Source: T1S1 (Proposed: USA)*

Subject: Proposed revisions to Annex D to ITU-T Q.2111

This contribution seeks editorial and technical improvement of ITU-T Recommendation Q.2111 Annex D (SSCOP in a Multiframe or Connectionless Environment when operating over Ethernet).

Figure D1. 802.3 MAC frame format

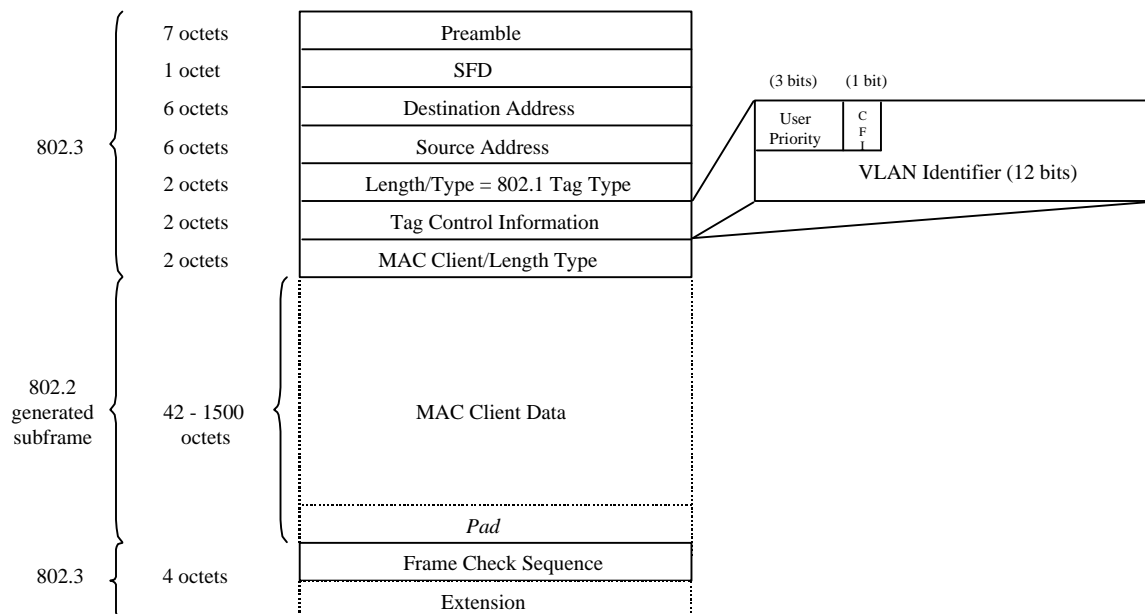
1. Figure D1 is revised to clarify the scope of the IEEE 802.2 and 802.3 standards, respectively.
2. Additional description of the Class of Service, CFI and VLAN sub-fields in the 802.1 tag is included.
3. References to other Ethernet frame types are deleted to focus the annex solely on IEEE-based Ethernet networks.
4. The use of the LLC header is removed from the text and the figures, since it is not used in the latest Ethernet implementations and, more importantly, since its intended function makes that header partially redundant with the function of the port identifier fields.

Figure D2. Service Data Unit and Parameters Passed Between SSCOP/Convergence Function and Ethernet – Transmitting Side

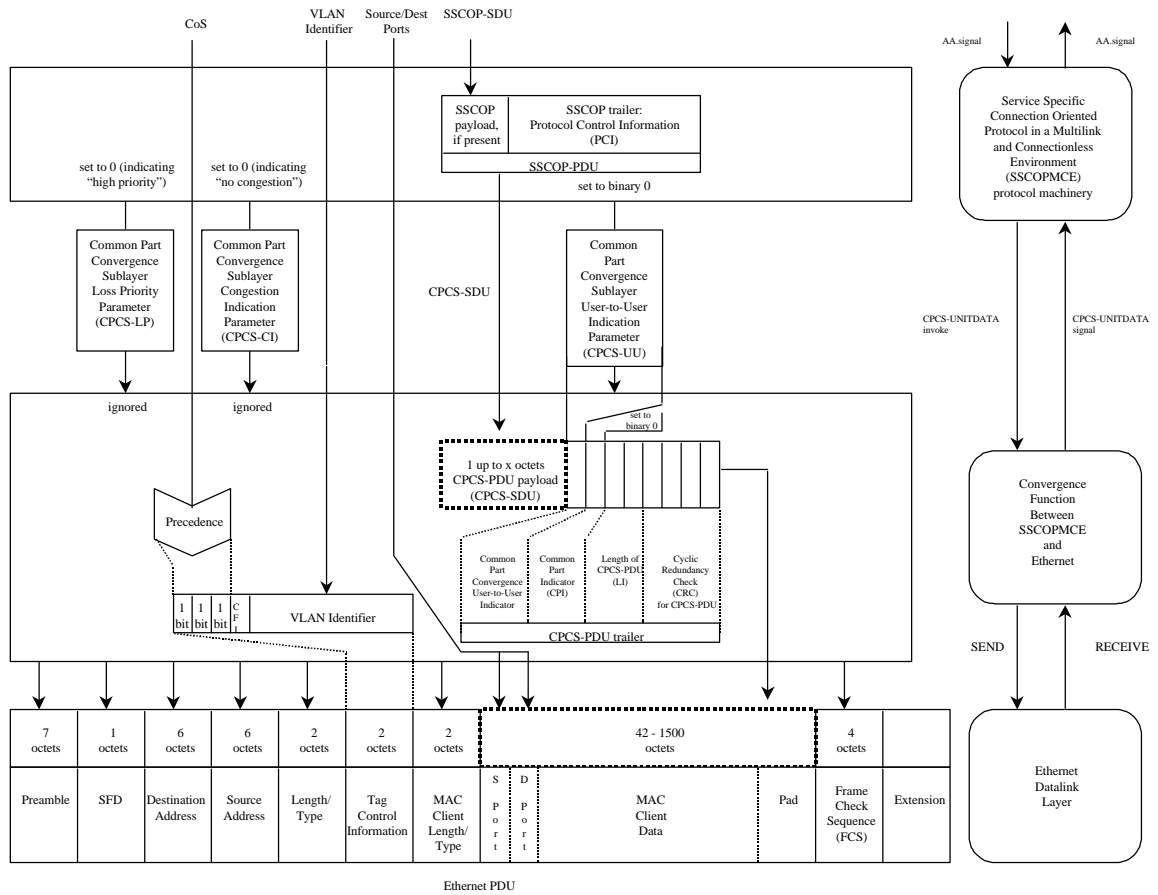
Figures D2 and D3 have removed depiction of the LLC header from the Ethernet PDU.

PDU ~~—specifically after the LLC field—~~ on the transmitting side (Fig. D2), and extracted and aligned with a complete SSCOP SDU on the receiving side (Fig. D3).
